### **Geotechnical Report and Peer Review**

**UPDATED GEOTECHNICAL REPORT**

**OAK CREEK CANYON  
5 LOTS - SUBDIVISION 6826  
APN #119-070-008**

**RESPONSE TO REVIEW COMMENTS BY ALAN KROPP & ASSOCIATES,  
DATED FEBRUARY 25, 2020**

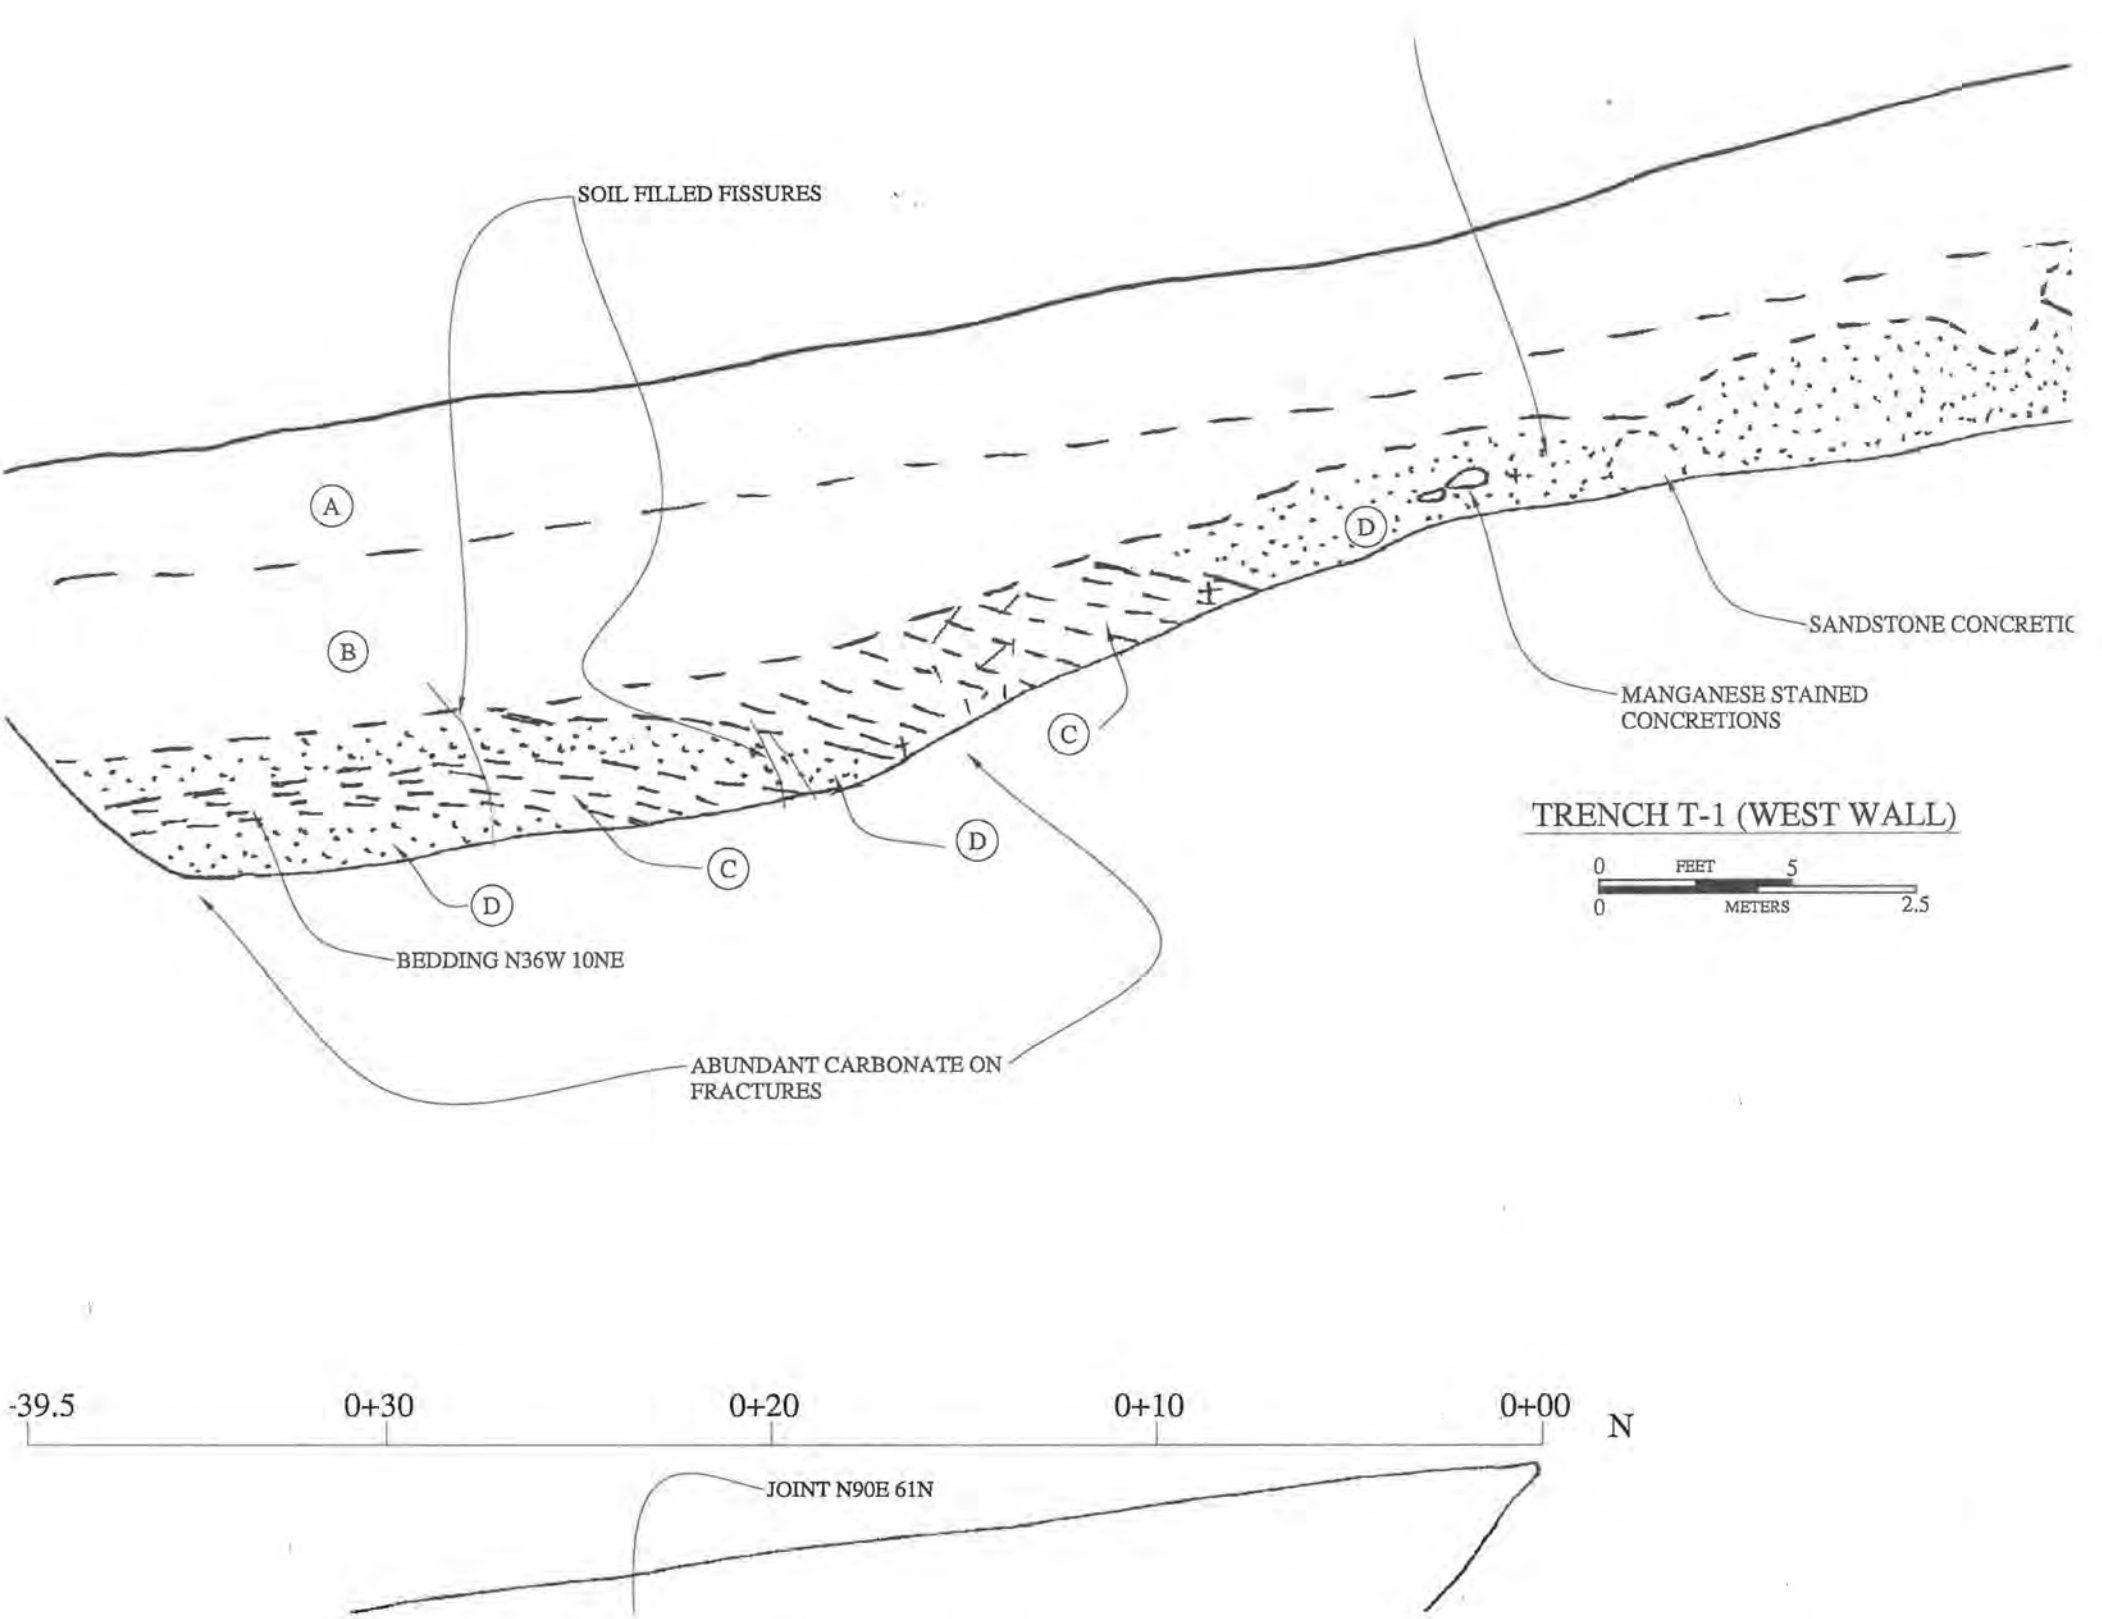
**Comment 2.** *There appear to be some differences between the corrective grading plans prepared by Engeo in 2008 and the recent draft copy we received. Key issues are the extent of remedial grading on Lots 3 to 5 and conforming remedial grading areas along the common property line with CCWD. The rationale for these differences should be provided. Also, the recent draft plan did not provide the locations of the 2008 trenches or the borings drilled on CCWD property, and this information should be added (assuming locations of borings on the CCWD property can be established).*

**ENGEO Response:** The remedial grading plan (draft) provided to AKA as part of their review was tentative and considered a work in process. Once the Civil Engineer 40-scale design plans are final, a final remedial grading plan will be prepared. We have provided locations of the 2008 trenches and borings in the attached Appendix. Once the construction plans are completed, we will update our remedial grading plan to include previous exploration locations, as well as recommendations for conforming grading along the shared property line with the CCWD property, and delineation of areas containing unsuitable material that needs to be removed and replaced, as shown in the 2008 Remedial Grading Plan (Reference 2).
